## *Landscape Briefing Note 7*

*Project:* 1080 East Anglia One North and East Anglia Two  
*Date:* 24<sup>th</sup> March 2021  
*Purpose:* Notes responding to SPR's Deadline 6 submission  
*Reference:* 1080 BN07 Responses to Deadline 6 submissions.docx

Outline Operational Drainage Management Plan - Version 03 24/02/21 **REP6-017**

# FIGURE 16

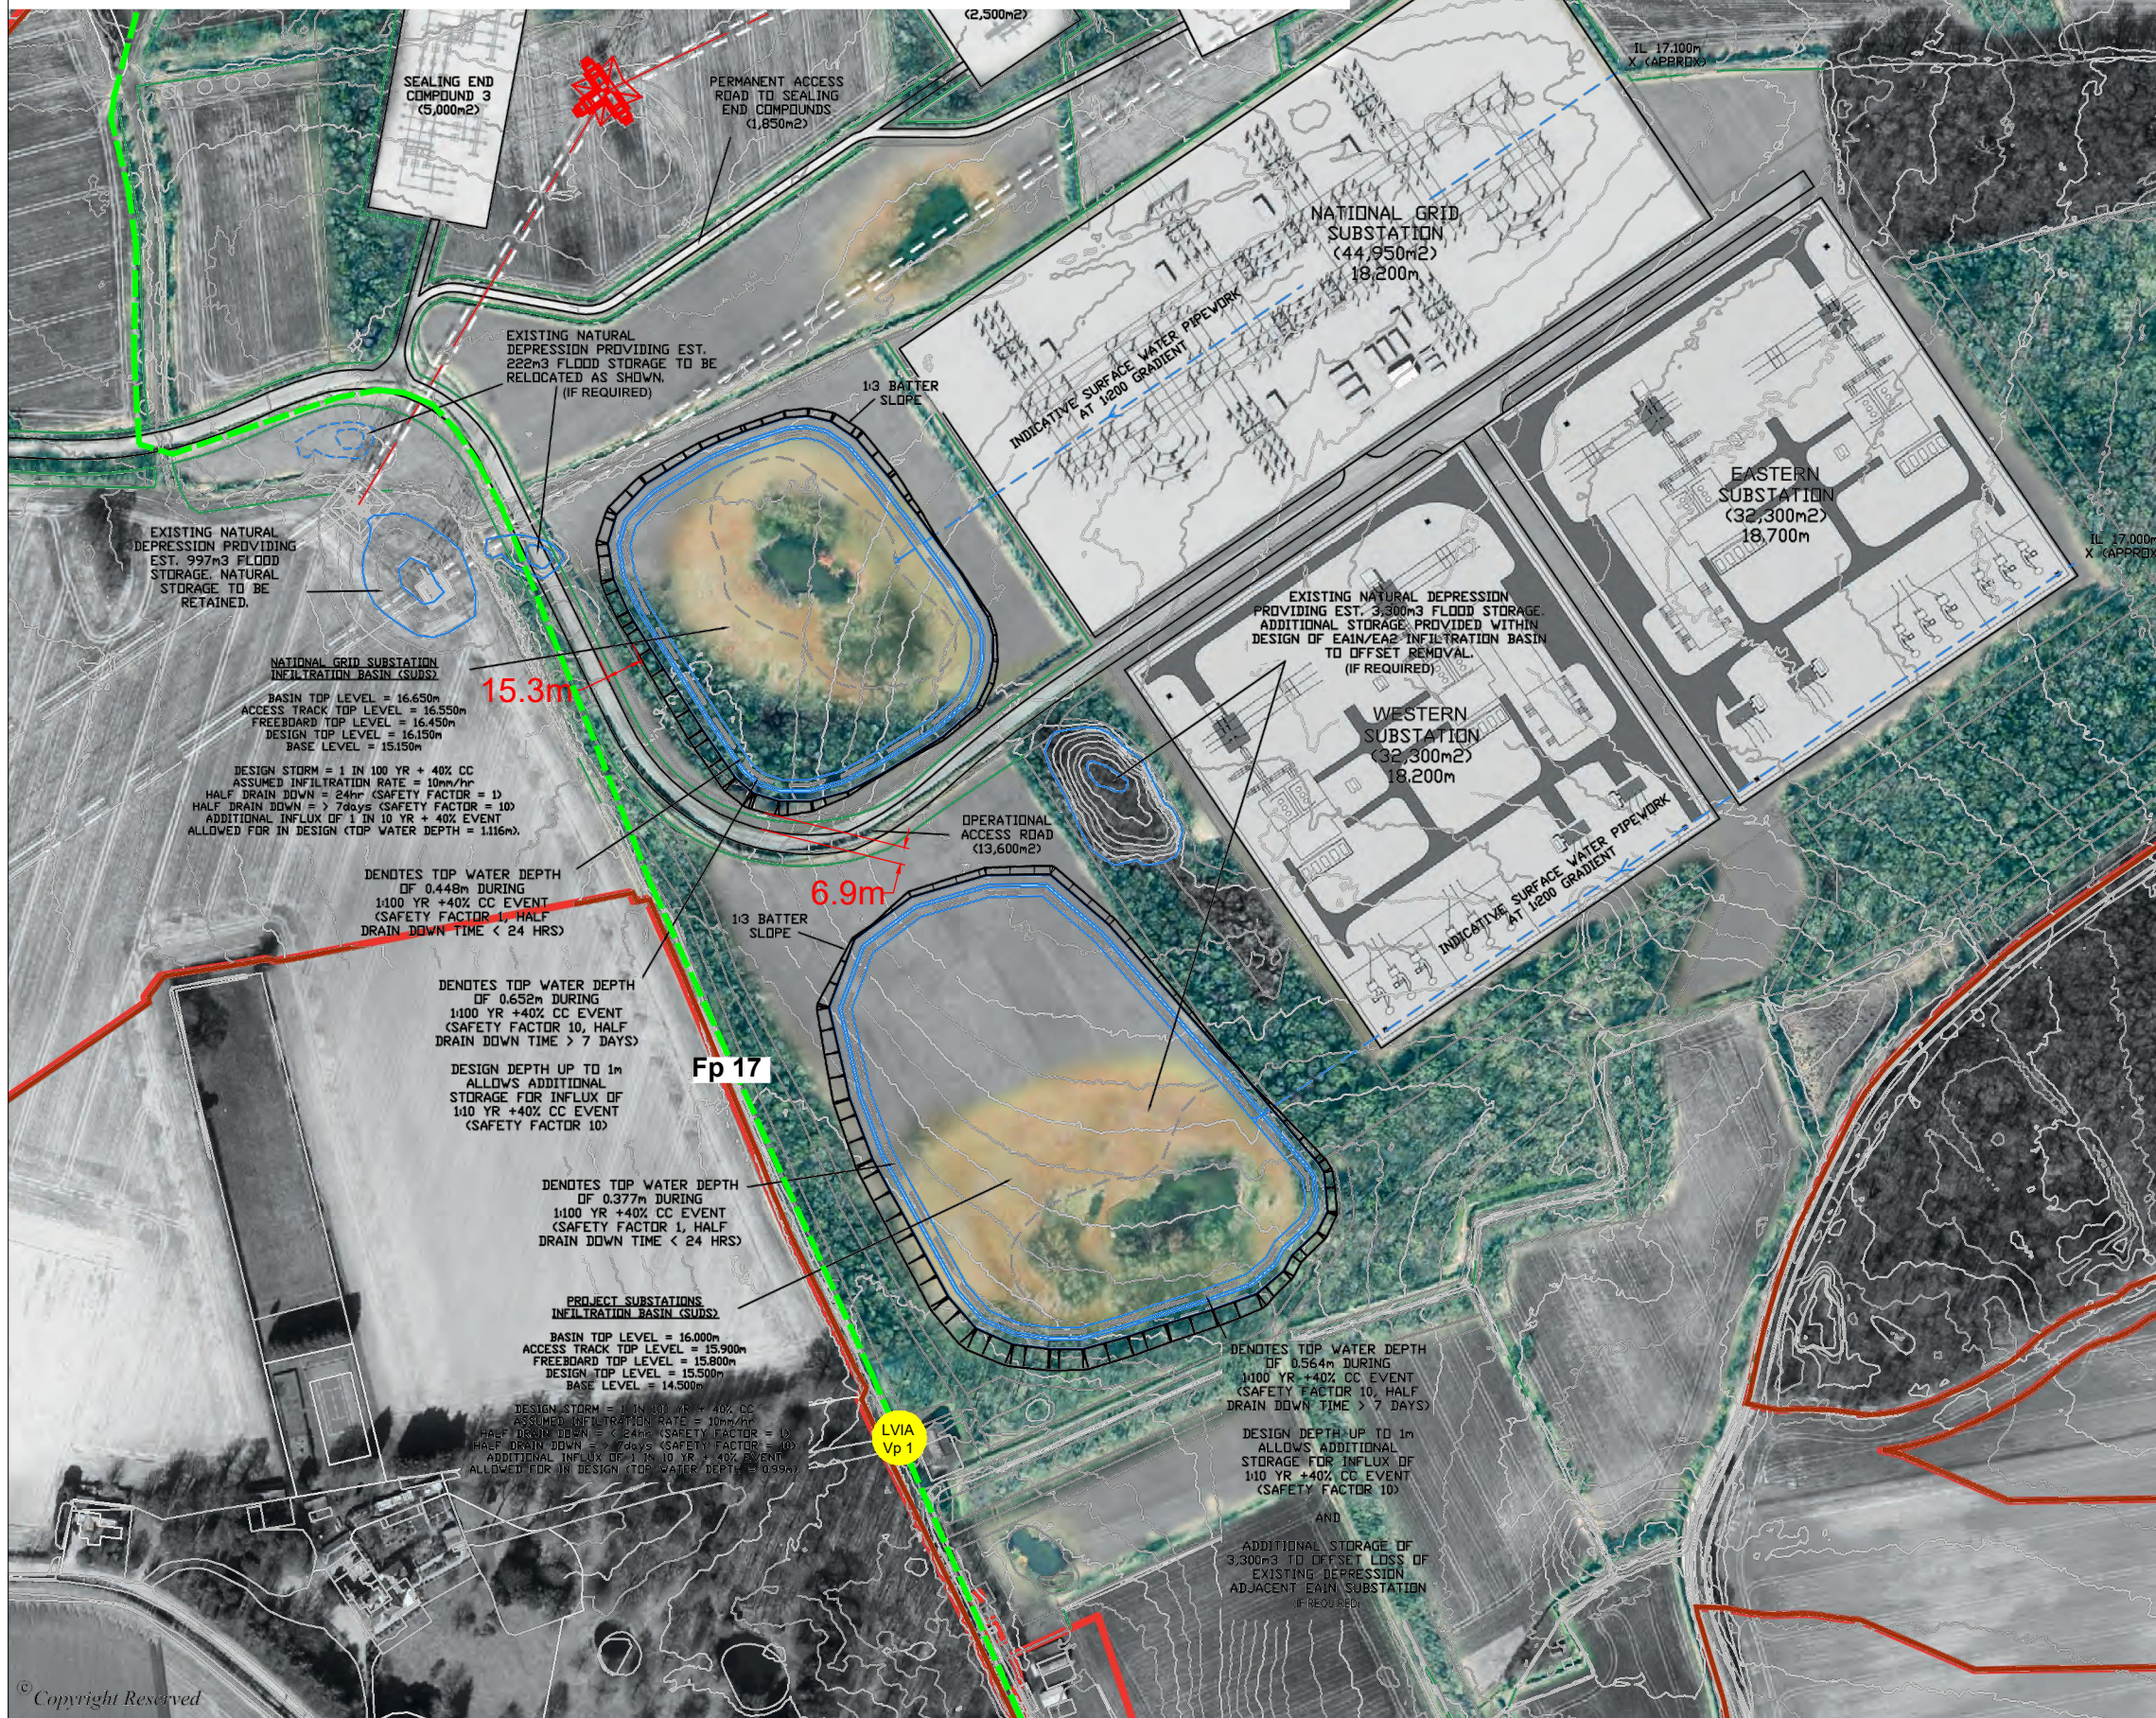
2. Figure 16 SUDS Overlay attached to this Briefing Note overlays Dwg ED11892-C-SK10 (Outline Operational Drainage Management Plan - Version 03 24/02/21 **REP6-017**) on the latest OLMP Proposed Planting Plan (Figure 6 in Outline Landscape and Ecological Management Strategy (OLMP) V03 24/02/21 **REP6-007**)

3. From Figure 16 it can be seen that the infiltration basins are considerably larger than the basins shown on the OLMP Proposed Planting Plan and would have the following consequences for the planting:

- The triangular area of mitigation woodland located to the south west of the northern basin would have to be omitted.
  - Whilst a small strip of planting could be accommodated to the west of the northern basin it would need to allow access to the embankments for maintenance purposes and would be constrained by the access road.

- Access to the embankments for maintenance purposes would reduce the area for woodland planting along the southern and western edges of the southern basin.

- 
4. The OLMP Proposed Planting Plan shows areas of tree planting within the infiltration basins. It is unclear why these have been introduced as they will require an overall enlargement of the area of infiltration basins. It is questionable whether trees in these locations and close to the edge of the basins would be compatible with the engineered structures of the Infiltration basins.

5. The OLMP V03 (**REP6-007**) was issued on the same date as the Outline Operational Drainage Management Plan - Version 03 (**REP6-017**) but does not reflect the proposed enlargement of the basins. This suggests that the landscape implications of enlarging the basins have not yet been considered.

6. The removal of the woodland from the southern and western edges of the northern infiltration basin will limit the effectiveness of the proposed mitigation in views from Footpath 17 which is located to the west of the proposed infiltration basins. The only LVIA Vp from Fp 17 is Vp 1. The grassed bund visible in the visualisation from Vp 1 (EA1N Landscape and Visual Impact Assessment Addendum - Appendix 1 - Viewpoint 1 **REP4-032**) is the edge of the drainage basin. The visualisation shows no planting on the embankments and, as set out above, a maintenance access strip would need to be kept clear along the foot of the embankment, further limiting the planting.

9. The embankments of both infiltration basins will now be close to and parallel with Fp 17 for approximately 350m. Previously only 80m of the southern basin was close to and parallel with Fp 17.

12. The new proposals for infiltration basins as set out on Dwg ED11892-C-SK10 (Outline Operational Drainage Management Plan - Version 03 24/02/21 REP6-017) will exacerbate the already significant harm to the visual amenity of the one remaining northbound PRoW to the north of Friston. They would further reduce the amenity of the landscape to the north of Friston as a resource for residents and visitors.
